Agenda
Village of Arlington Heights
Design Commission
Community Room, 3rd Floor

Arlington Heights Village Hall
33 S. Arlington Heights Road
Arlington Heights, IL 60005
February 27, 2018
6:30 PM

MINUTES OF
THE VILLAGE OF ARLINGTON HEIGHTS
DESIGN COMMISSION MEETING
HELD AT THE ARLINGTON HEIGHTS MUNICIPAL BUILDING
33 S. ARLINGTON HEIGHTS RD.
FEBRUARY 13, 2018

FRONT ELEVATION
SCALE: 1/4"=1'-0"
© JMB ARCHITECTS LTD.

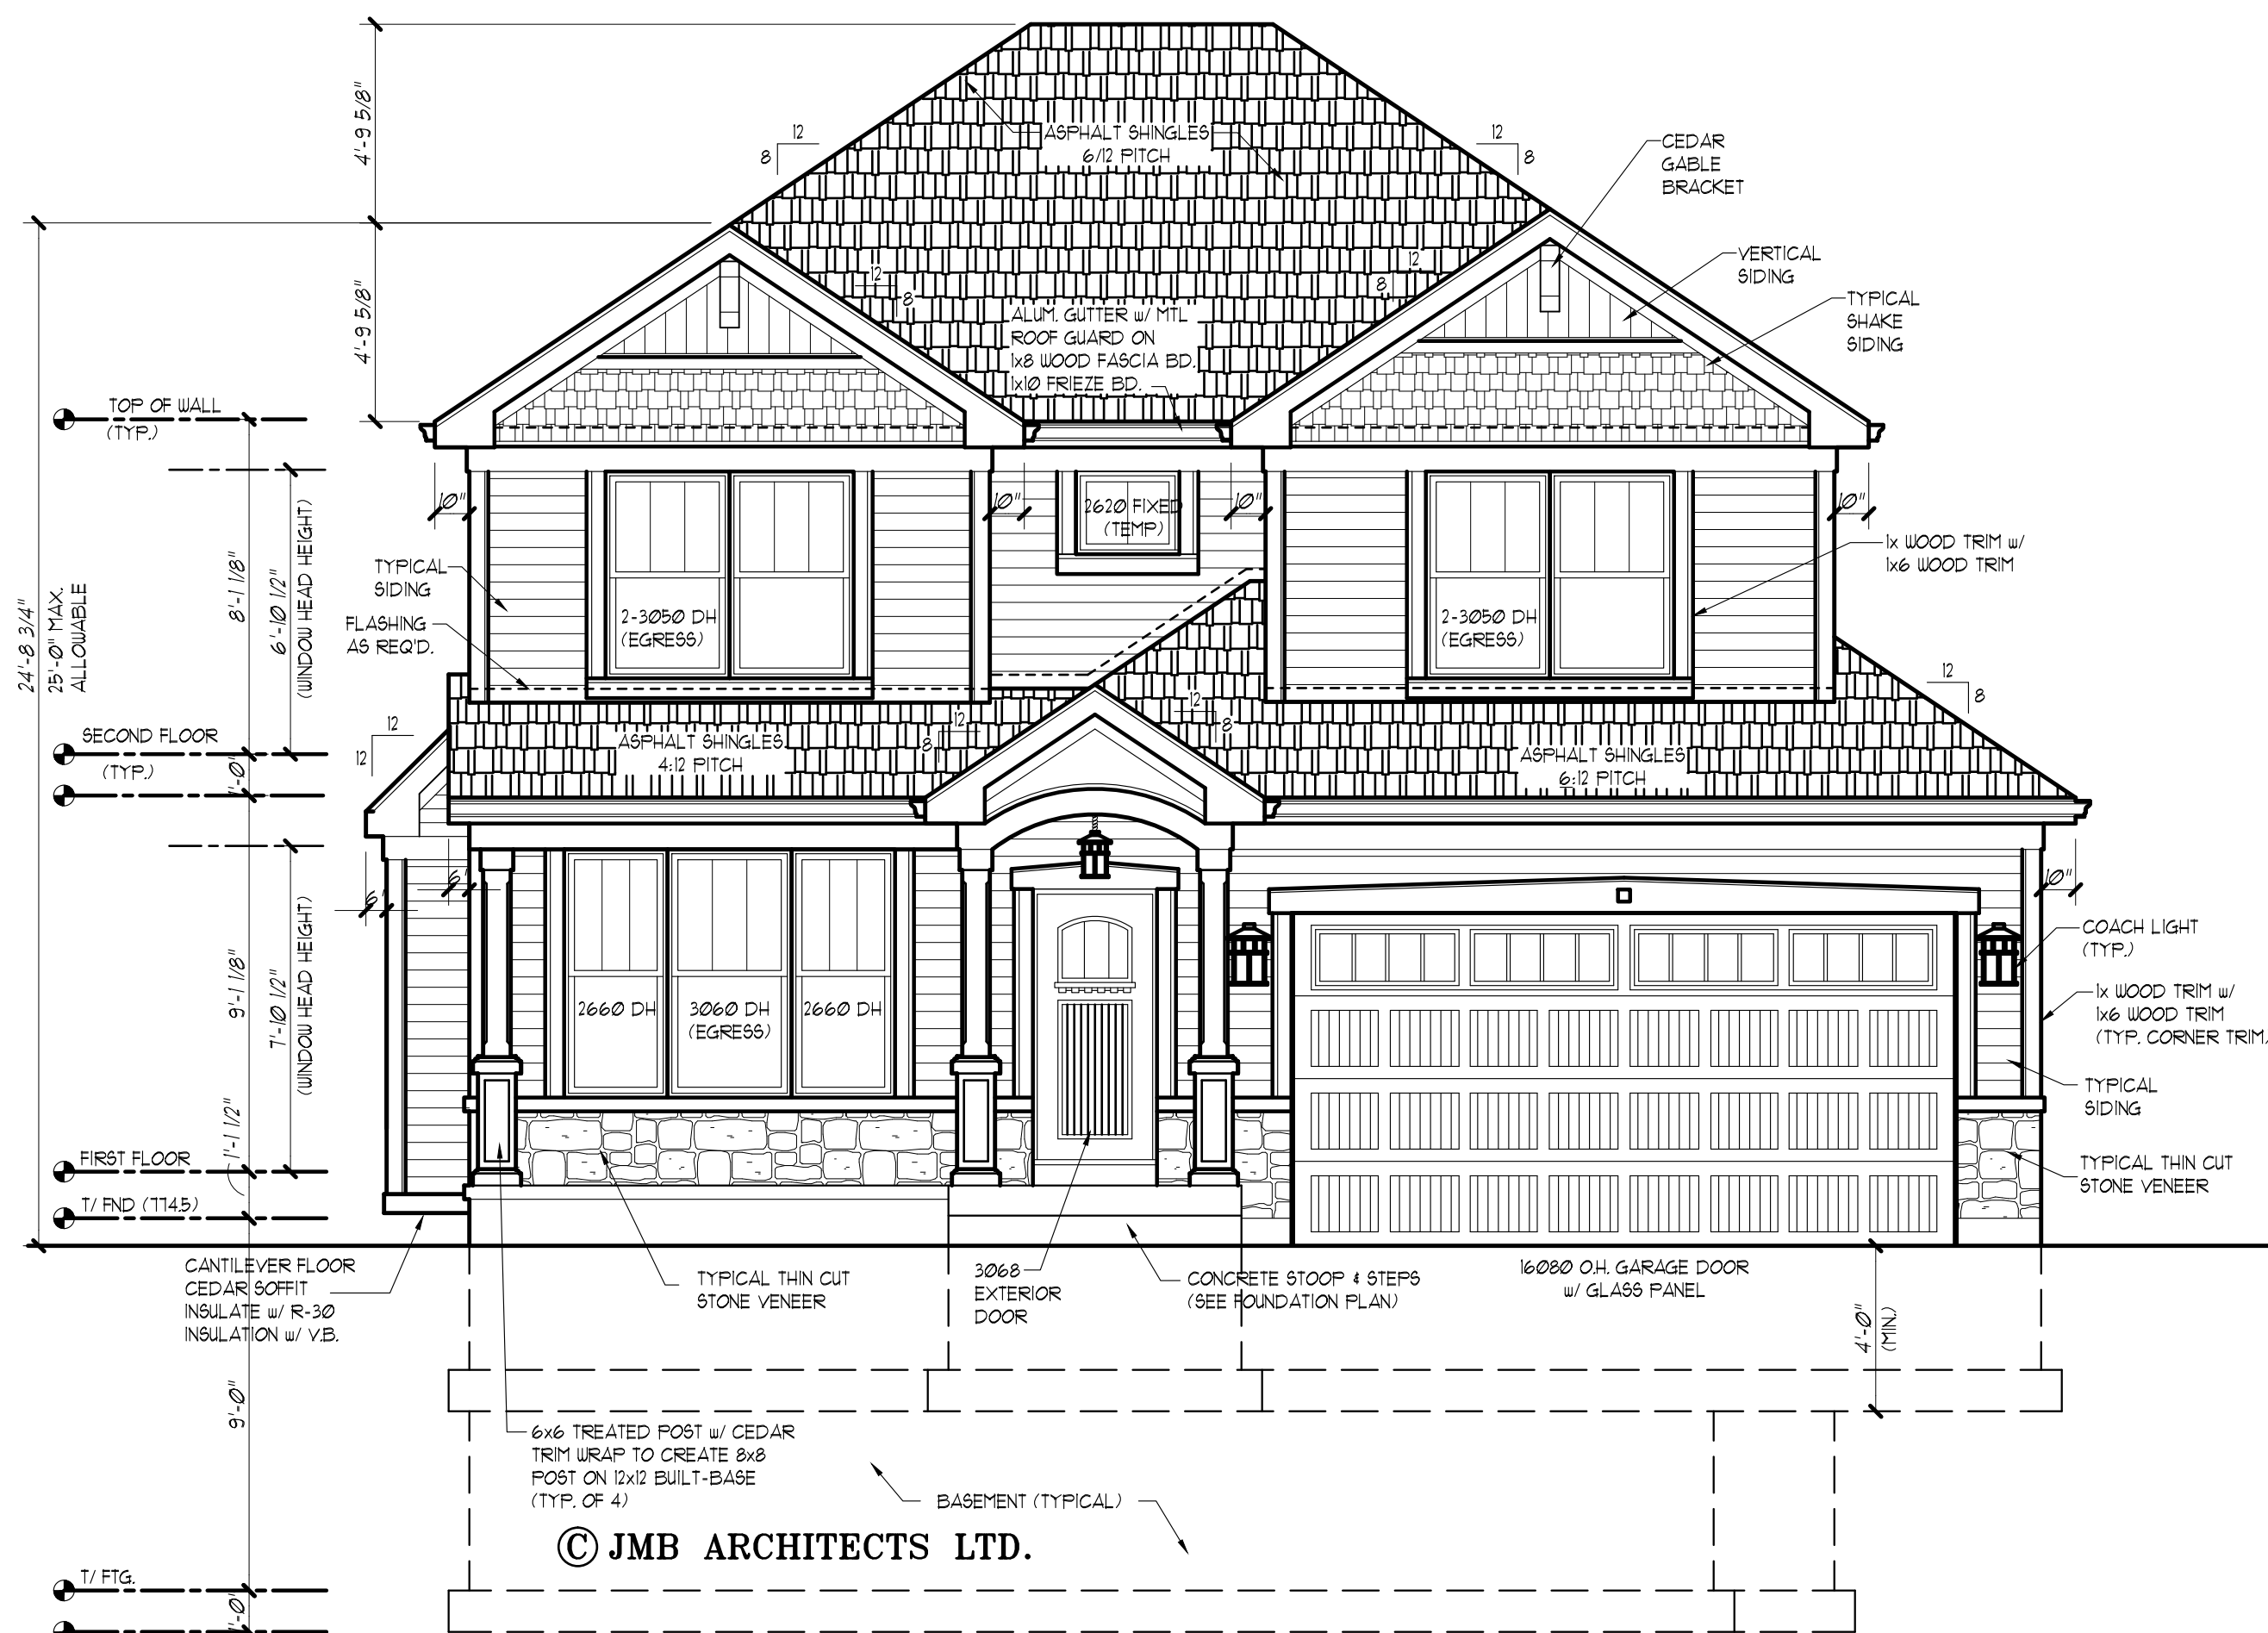
- The roof pitch was reduced on the sides of the house from 12:12 to 8:12.
- A window was added to the side of the garage to break up the wall of siding.
- A stone base was added to the front of the house.

Overall, the proposed design is nicely done with a single-story porch and garage roof that help the design to relate to the scale of the adjacent houses. The reduced roof pitch now fits the scale of the neighborhood. The only comment on the design is to wrap the stone base down the north wall of the garage and partially down the south wall of the house.

1. Wrap the stone base down the north wall of the garage and partially down the south wall of the house.
2. This review deals with architectural design only and should not be construed to be an approval of, or to have any other impact on, any other zoning and/or land use issues or decisions that stem from zoning, building, signage or any other reviews. In addition to the normal technical review, permit drawings will be reviewed for consistency with the Design Commission and any other Commission or Board approval conditions. It is the architect/homeowner/builder's responsibility to comply with the Design Commission approval and ensure that building permit plans comply with all zoning code, building permit and signage requirements.
3. Compliance with all applicable Federal, State, and Village codes, regulations and policies.

PROPOSED WEST ELEVATION

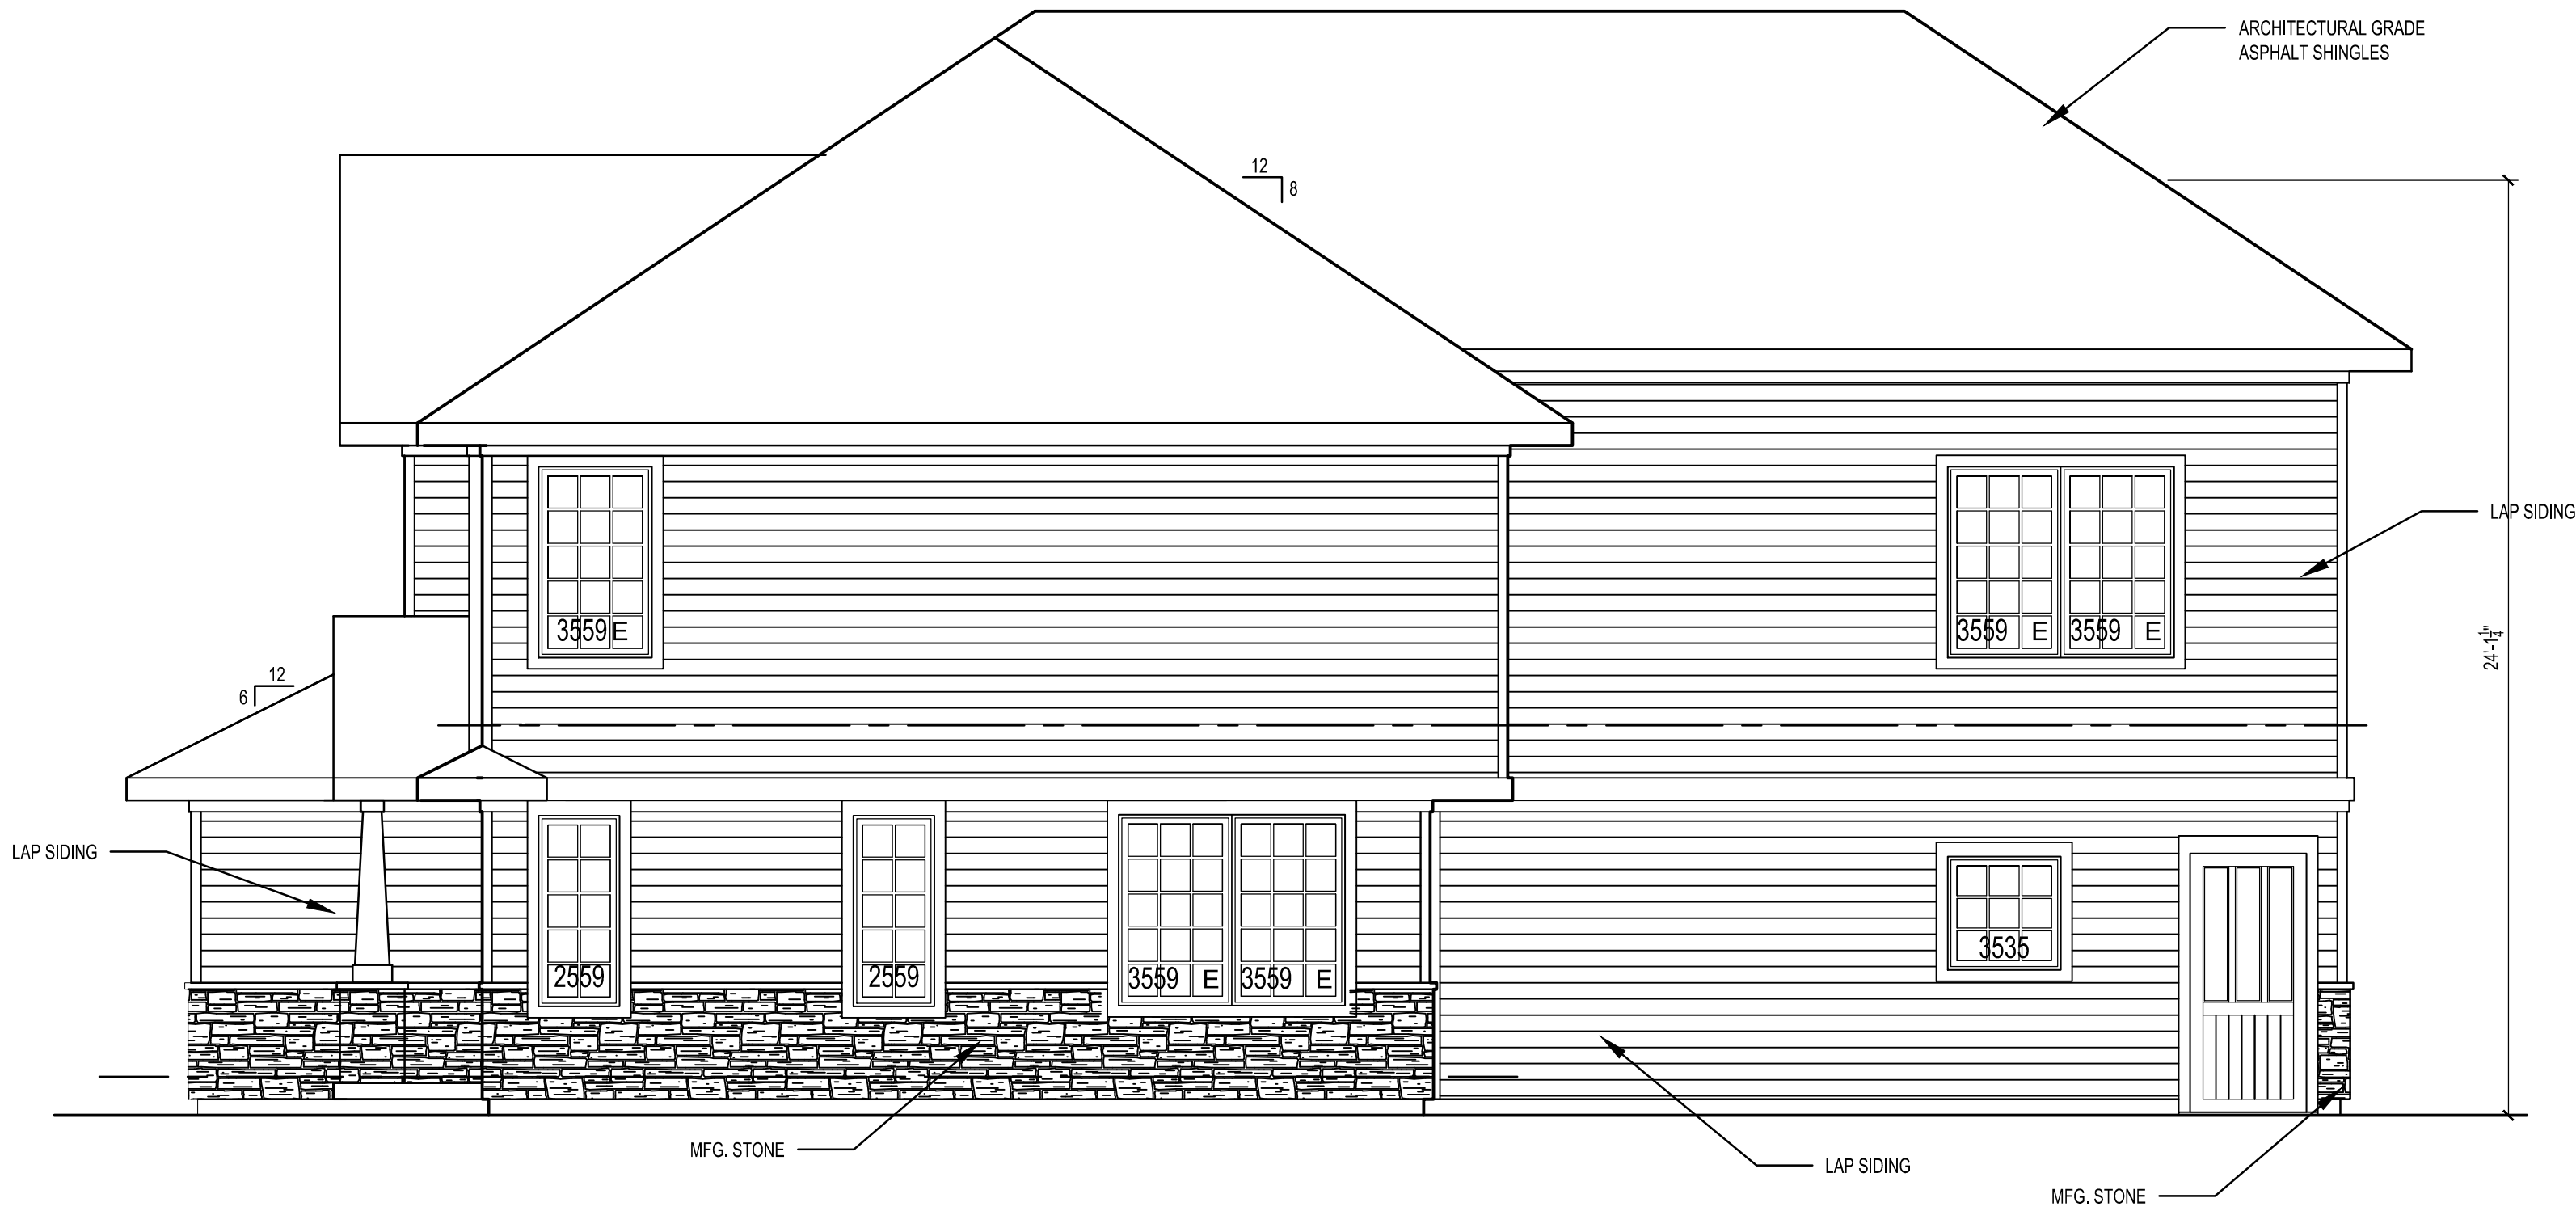
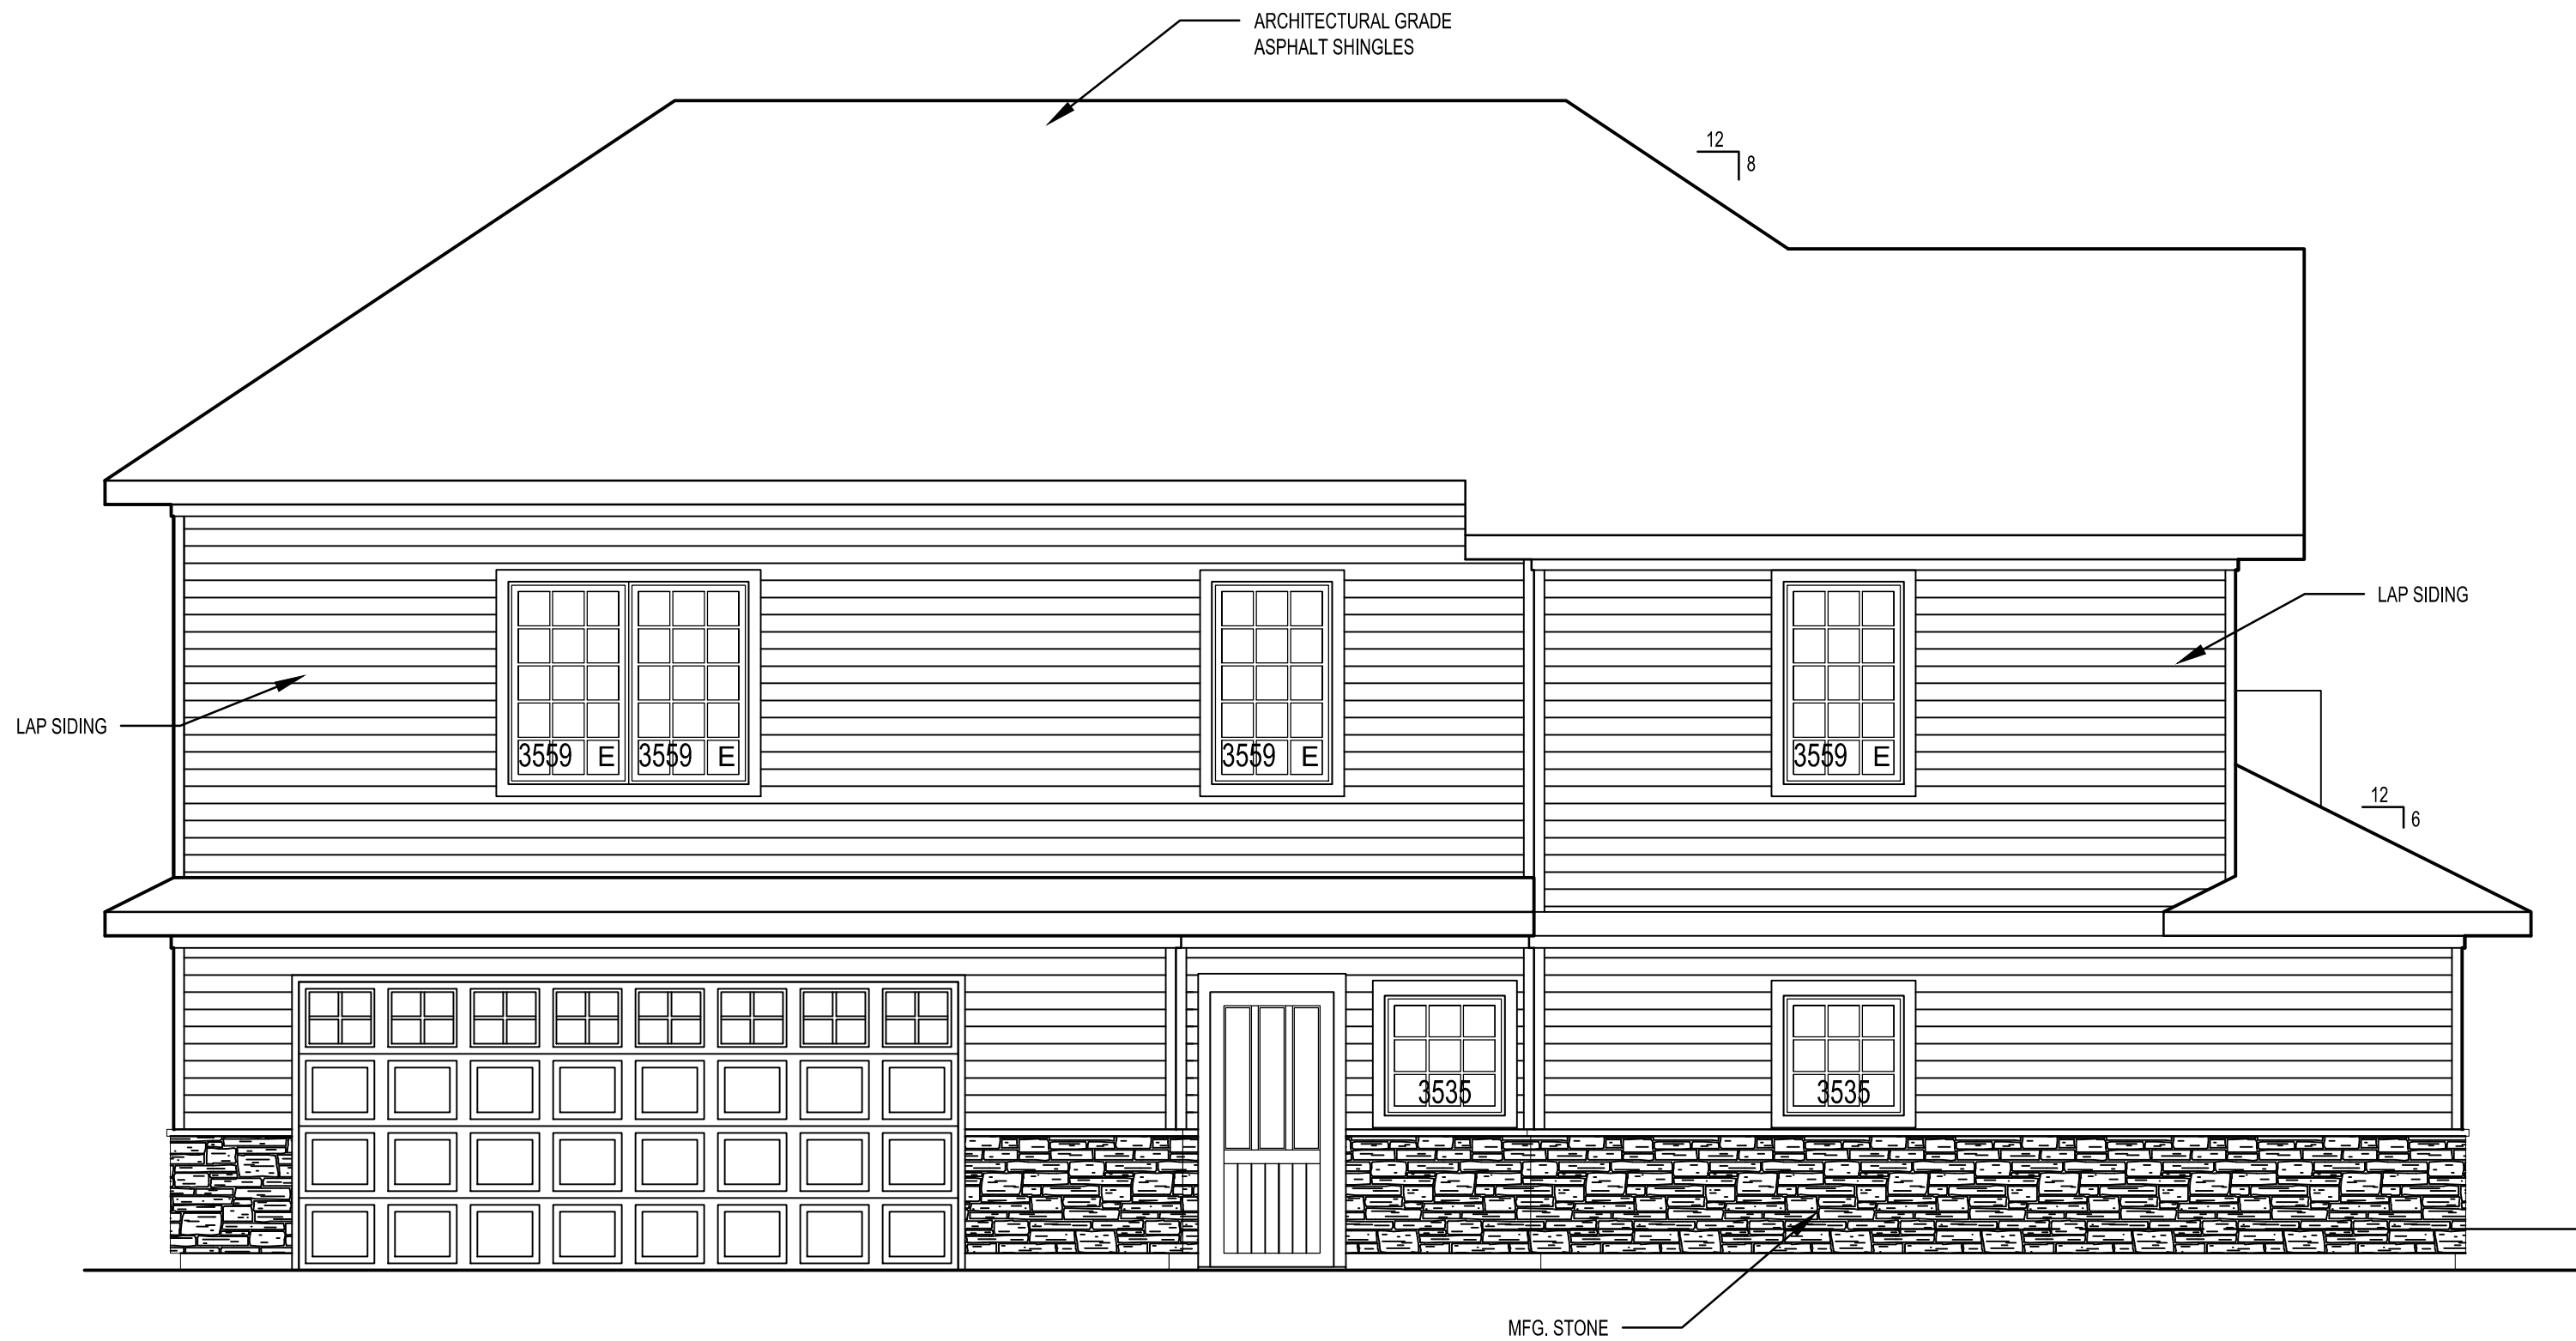
1. Revise the second floor gutter line to be at a consistent level on all sides of the house.
2. Revise the stone selection to a larger format masonry unit.
3. This review deals with architectural design only and should not be construed to be an approval of, or to have any other impact on, any other zoning and/or land use issues or decisions that stem from zoning, building, signage or any other reviews. In addition to the normal technical review, permit drawings will be reviewed for consistency with Design Commission and any other Commission or Board approval conditions. It is the petitioner's responsibility to comply with the Design Commission approval and ensure that building permit plans comply with all zoning code, building permit, and signage requirements.
4. Compliance with all Federal, State, and Village codes, regulations and policies.
